CASE SUMMARY SHEET

CASE NUMBER: V23-04-12

REQUEST: V23-04-12 – Allison and Brian Froeba request a variance to CLURO Section 9.2.5.2. Vegetation Protection Zones, Square 5 Lot 6A, R-1 Single Family Residential District, 1617 Lakeshore Drive

To: Cara Bartholomew
From: Catherine Fuselier
Date: April 11, 2023
Subject: V23-04-12

BUILDING SETBACK AND CONCRETE DRIVE PLAN

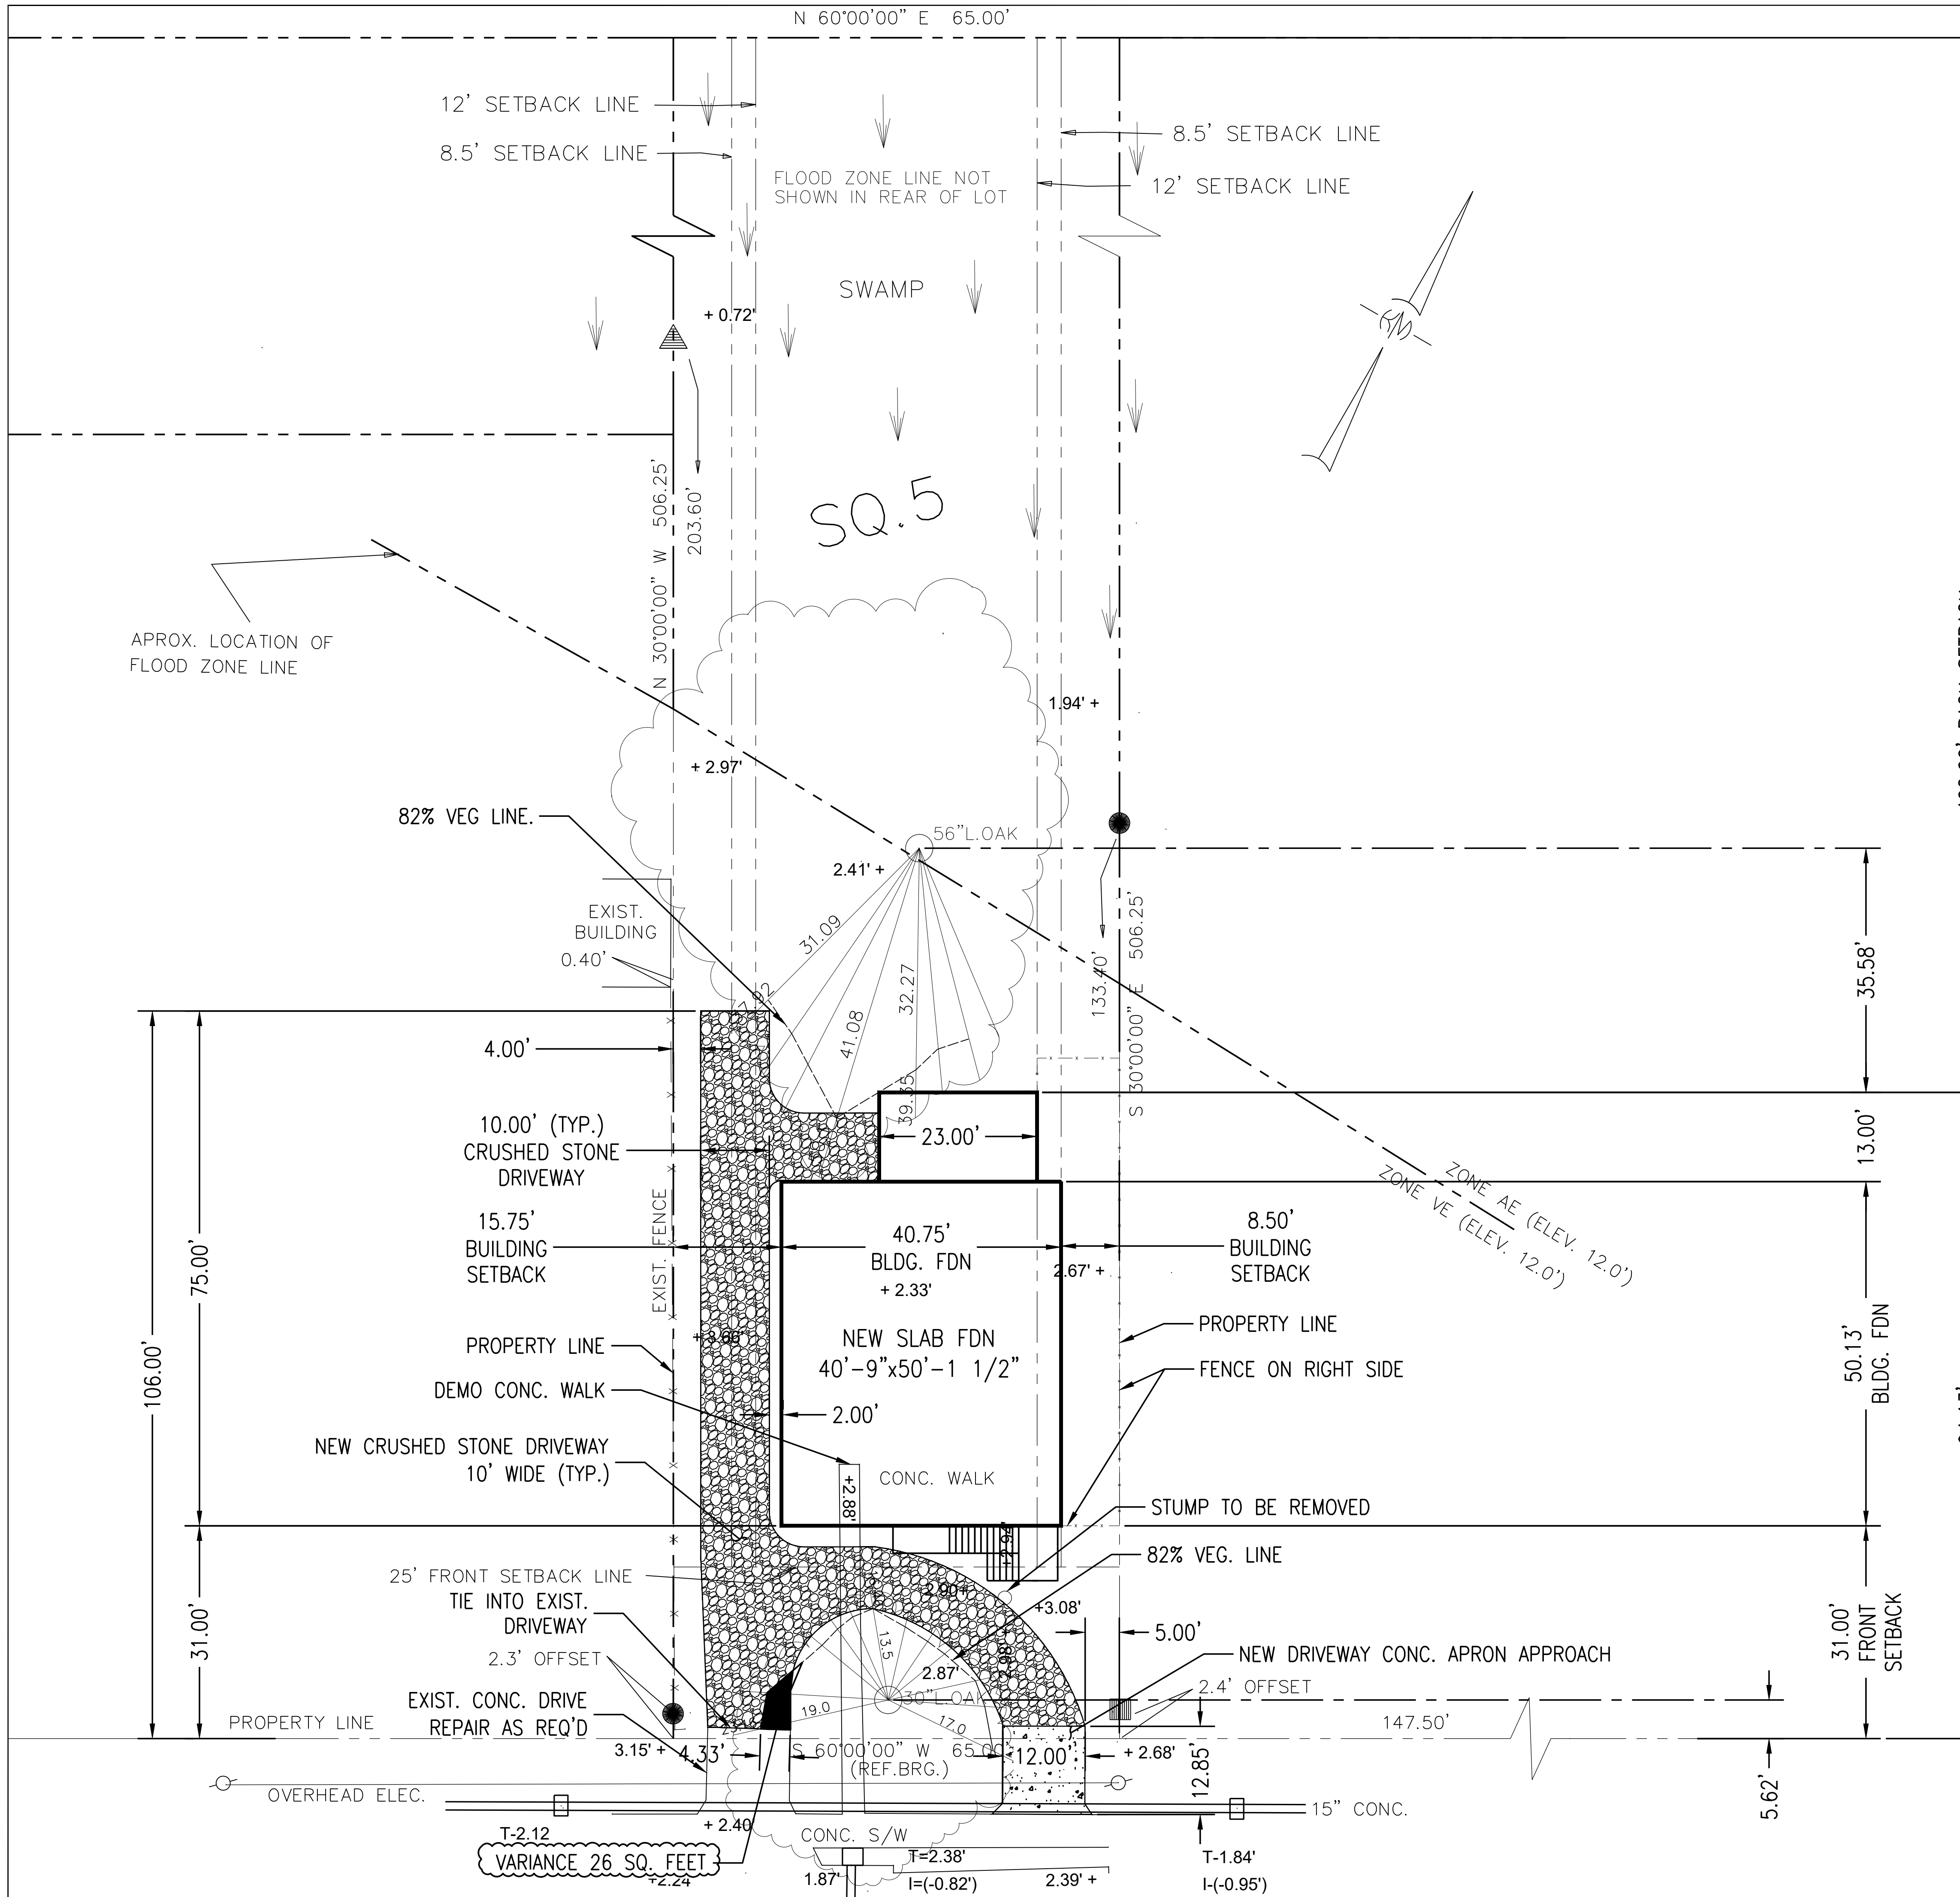
The driveway encroachment in question is to be constructed of a pervious material that is labeled as limestone gravel. While the limestone drive is pervious and allows for water infiltration and minimal compaction there are five areas of concern and recommendations.

- 1) Most contractors will dig down to install a curbing to keep the gravel from spreading out from within the perimeter of the driveway. This can be corrected as simple as installing a landscape edging or by using a curbing that lies on top of the ground and anchored into the ground with a material such as rebar.
- 2) Normal practice of driveways is to compact the soil with red clay before laying the gravel. This step will need to be skipped completely and the gravel should be laid directly on top of the uncompacted soil.
- 3) As the existing driveway is also the access into the site the drivers of all heavy equipment, machinery, and vehicles will need to take extreme caution when driving under and around the live oaks to make sure they do not damage any of the branches or the root systems when entering or exiting the lot. A maximum

height clearance should be established based on the lowest limb to ensure that vehicles or equipment do not damage any of the limbs of the tree. While the driveway is feasible from a normal day to day access it could run into problems being the access drive during construction. If the homeowners/contractors take extreme caution while around this tree and follow a proper tree preservation plan it is possible for the driveway to work. If extreme caution is not taken then the trees could potentially be damaged by tall trucks accessing the site or the soil could be deeply compacted if proper tree protection fencing is not used.

- 4) The aggregate limestone driveway should be size #57. This sizing offers multiple aggregate sizing that are the least likely to compact. Aggregates of the same size can over time compact down and cause the same issues that a non-pervious material type can cause. The use of multiple aggregate sizing will help prevent this from happening and should be used.

1. Curbing shall be installed at grade and anchored into the ground with material such as rebar. No digging shall be done to install curbing.
2. Driveway materials shall be laid directly on top of the uncompacted soil. No digging or compacting of the soil shall be allowed under the canopy of the live oak.
3. A maximum height clearance should be established based on the lowest limb to ensure that vehicles or equipment do not damage any of the limbs of the tree.
4. The aggregate limestone driveway should be size #57 or a comparable product, to be approved by the Landscape Inspector.

SITE PLAN
 SCALE: 3/32" = 1'-0"

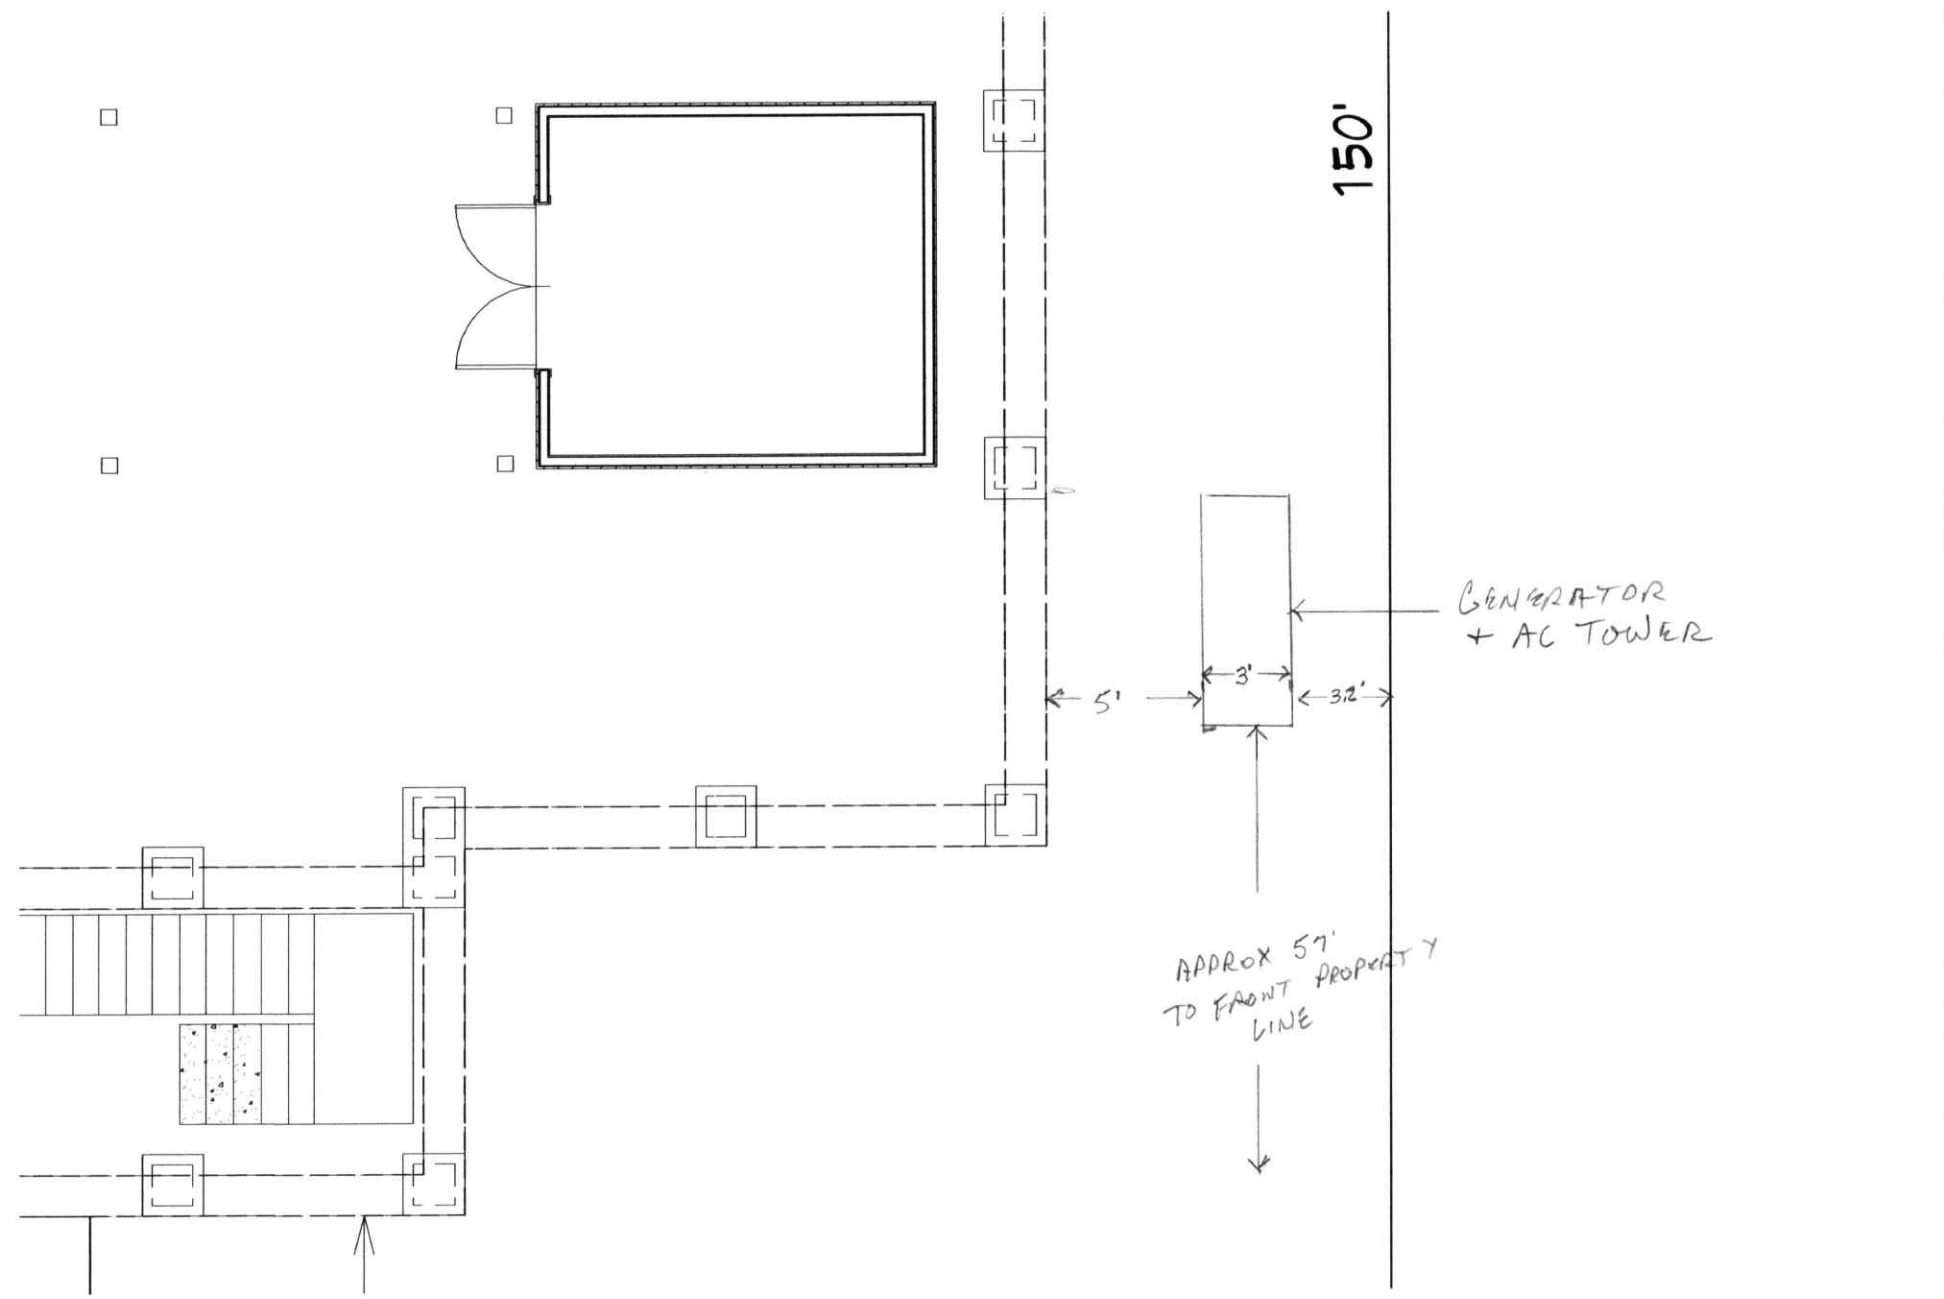
The applicant is requesting an exception to encroach into the west side yard setback to place a generator. The lot has a frontage of 100' requiring side yard setbacks of 16'. The west side setback is currently 11.3' and the east side setback measures 21' due to the allowed 30% flex. The proposed location of the generator would encroach 8' into the west side setback, leaving a remaining setback of 3.2'

1 SITE PLAN
1/8" = 1'-0"

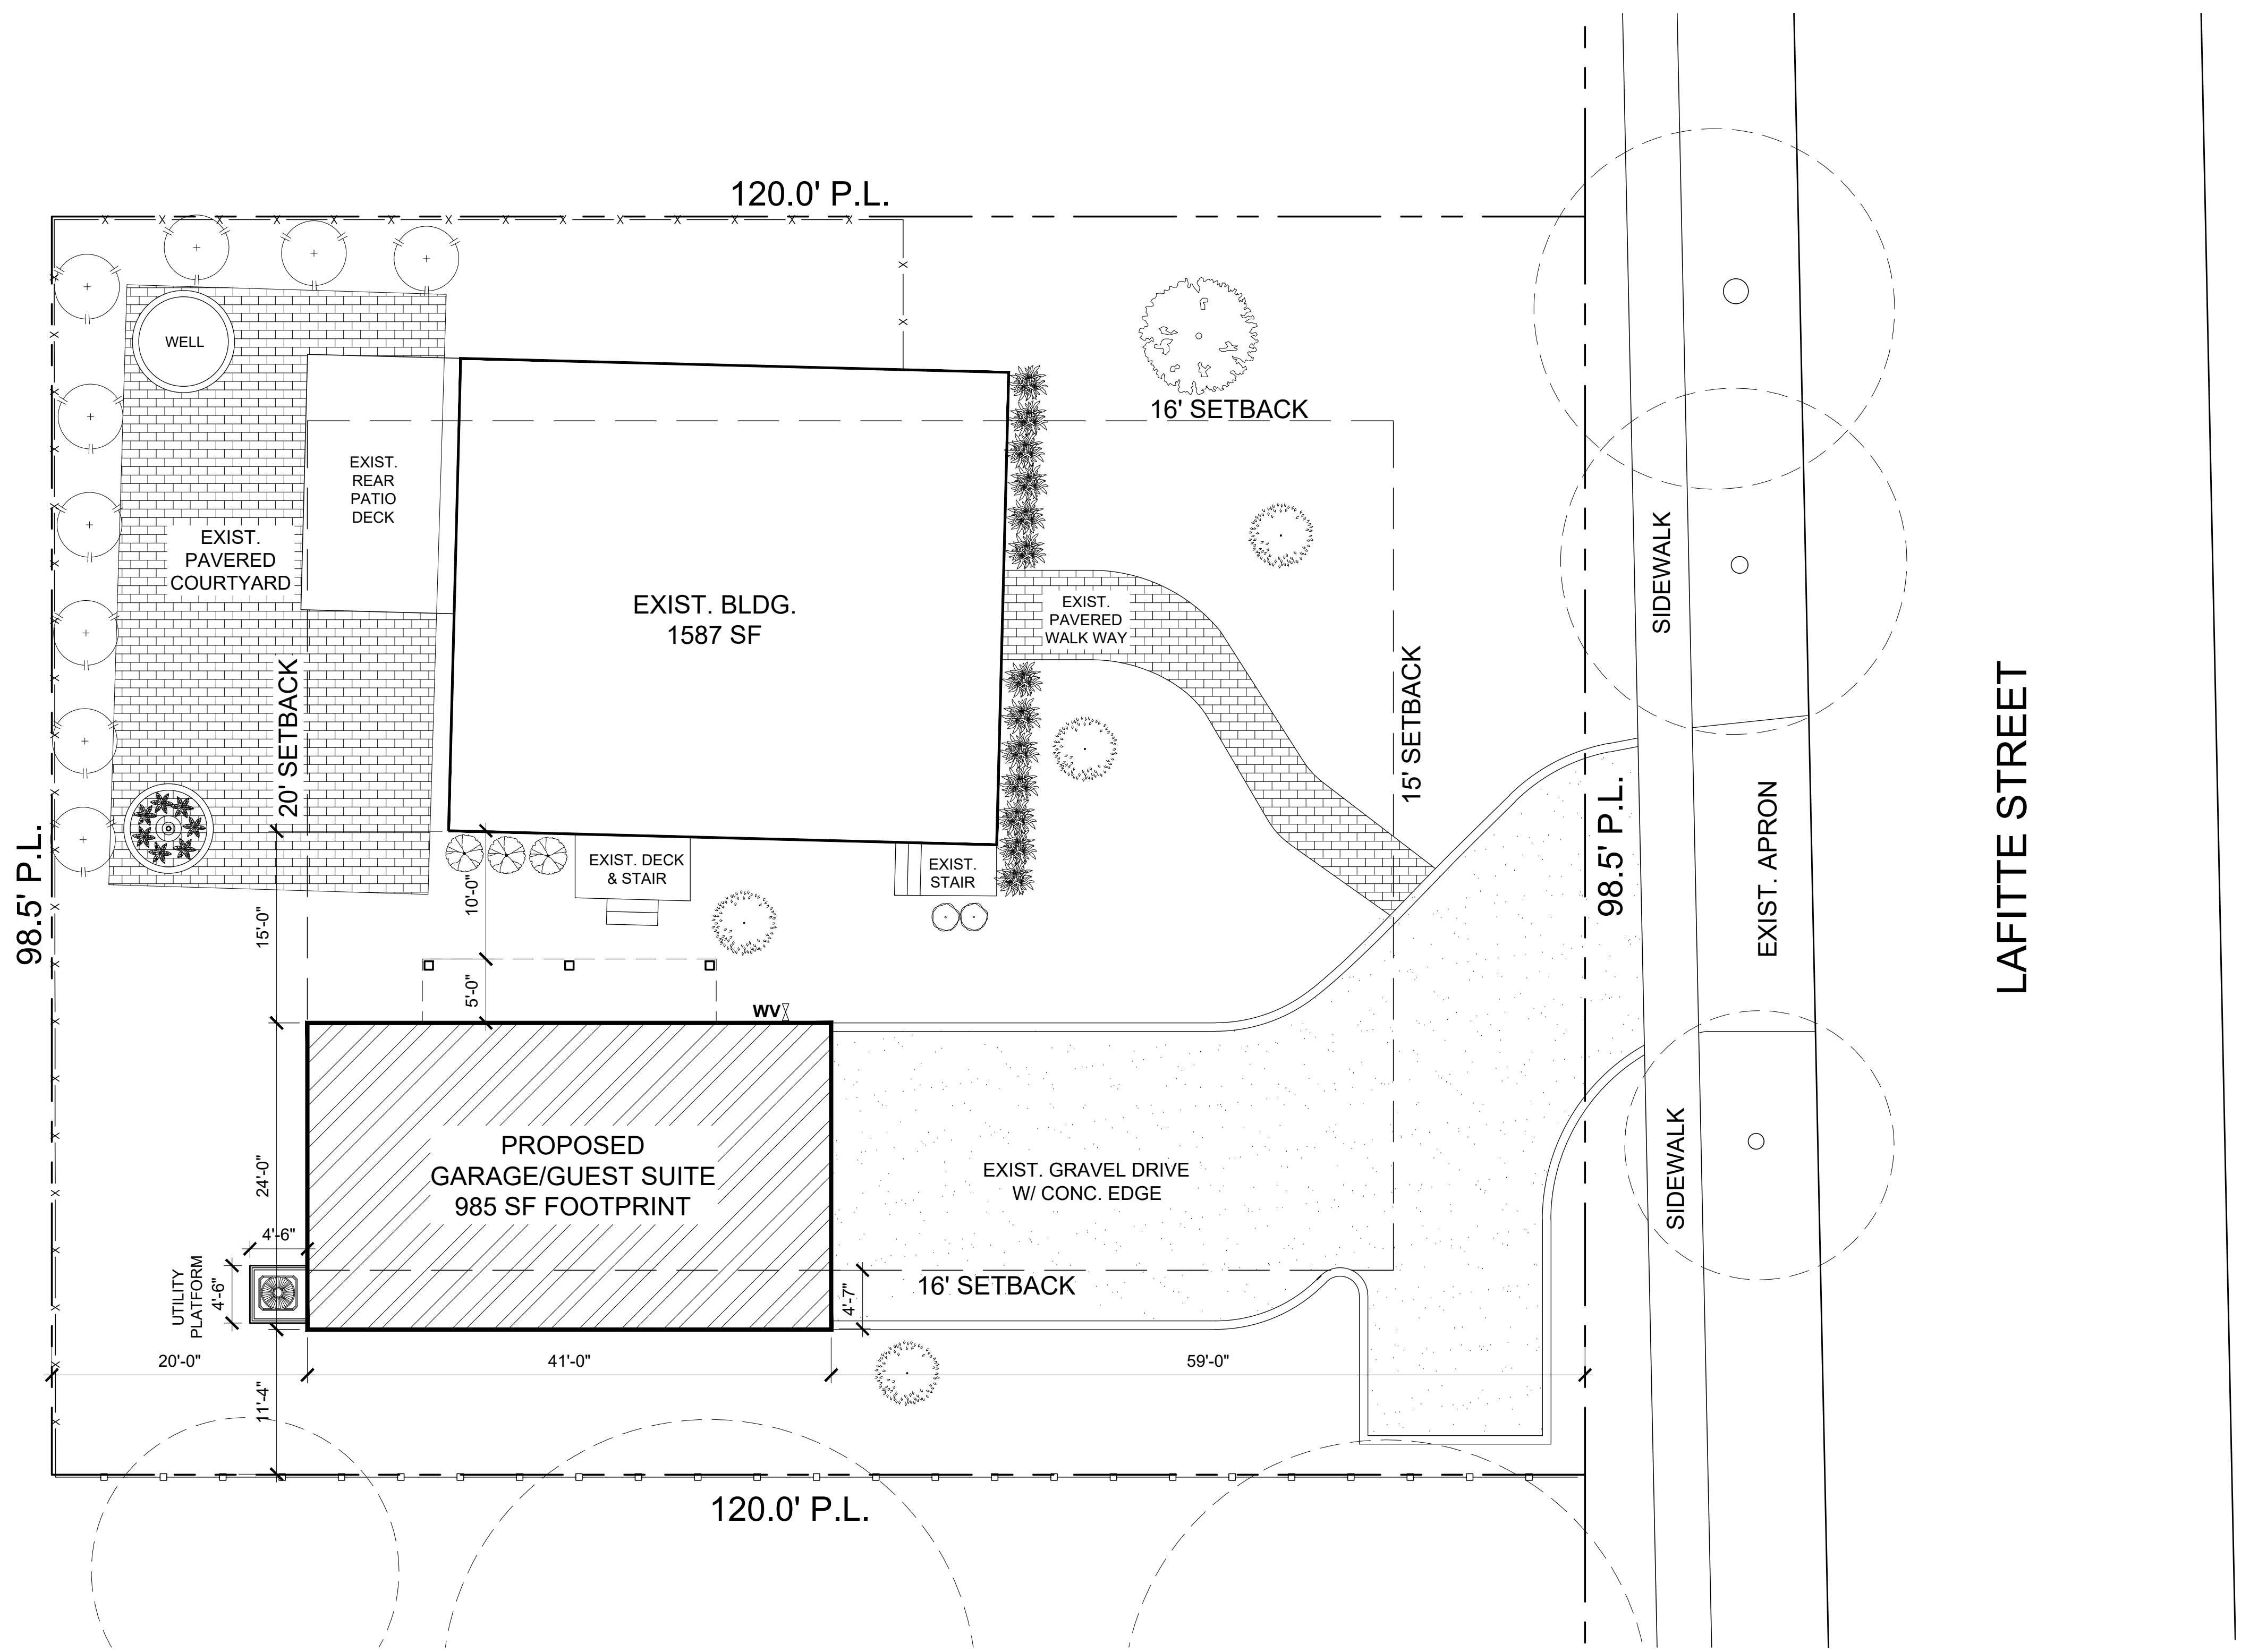
The applicant is requesting to construct a two-story garage and guest suite being 985 sqft. The B-3 District allowed for an accessory dwelling unit. The proposed structure is in accordance with Section 8.1.14 Supplemental Regulations for Accessory Dwelling Units. Should the building be converted into Commercial uses the State Fire Marshall requires a 10’ setback between buildings. To maintain the required 10’ of space between the two buildings, the guest suite will encroach into the south setback by 4’-7”.

The lot has a frontage of 98’ requiring 16’ side setbacks. The proposed garage and guest suite would encroach into the setback by 4’-7” leaving a setback distance of 11’-4”. The building can not utilize the flex due to the existing buildings encroachment into the setback. The accessory structure would be compliant with the flexibility.
